**PZ&B Staff Combination Memorandum: Landmarks Preservation Commission and Town Council**

**SUBJECT:** HSB-22-012 (ZON-22-121) 428 CHILEAN AVE (COMBO)

**HSB-22-012 (ZON-22-121) 428 CHILEAN AVE—FLOODPLAIN VARIANCE (COMBO).**

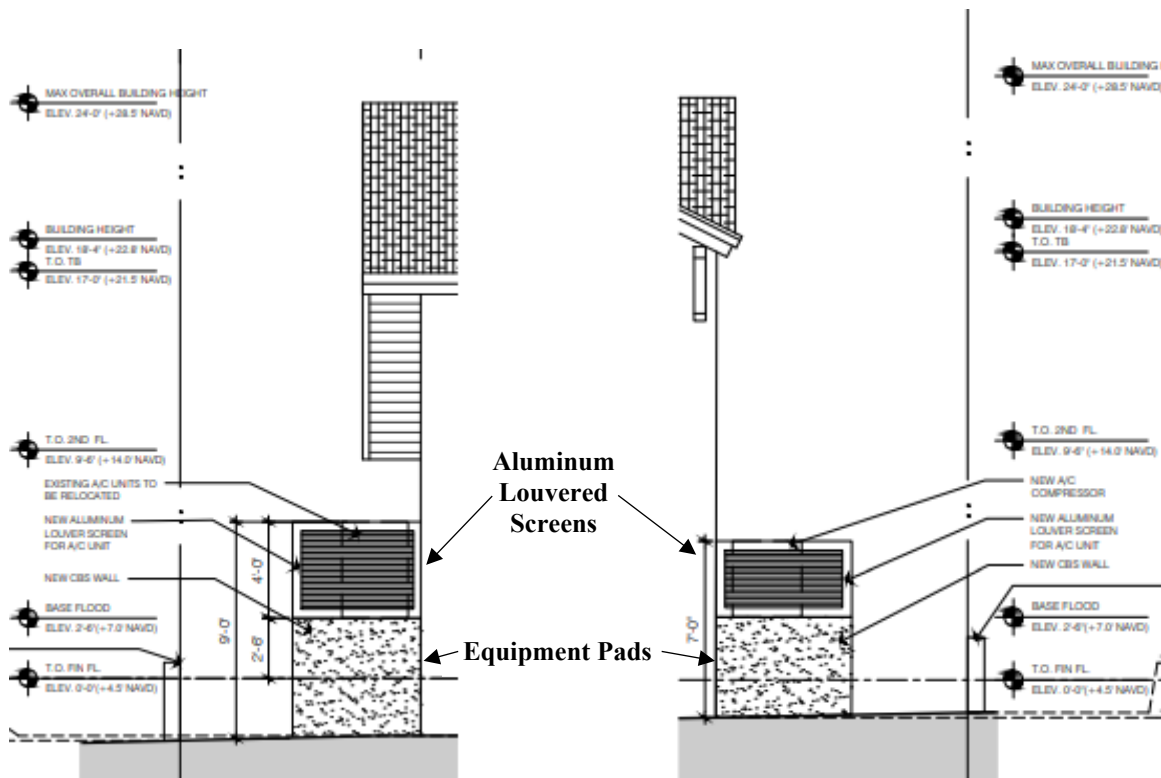
As it pertains to **Variance #2**, the applicant seeks to screen the proposed air conditioning condensing units in the east and west yards with new aluminum louvered screen panels in lieu of the masonry walls required by code.

The subject parcel is very low, with a crown-of-road just under 2' NAVD. FEMA requirements mandate that new equipment be installed at minimum flood elevation, which is 7' NAVD. In doing so, the equipment must be physically raised off grade to the minimum requirement. Equipment located within yard areas are required to be screened by masonry walls as high as the equipment but are not permitted to exceed maximum wall heights. If the applicants chose to install a masonry screening wall to the top of the equipment, they would also need a variance to exceed wall heights within a side yard to 9' in height in lieu of the 7' permitted. The yard section diagrams below illustrate the proposed air conditioning equipment pads and aluminum louvered screening in the east and west yards.
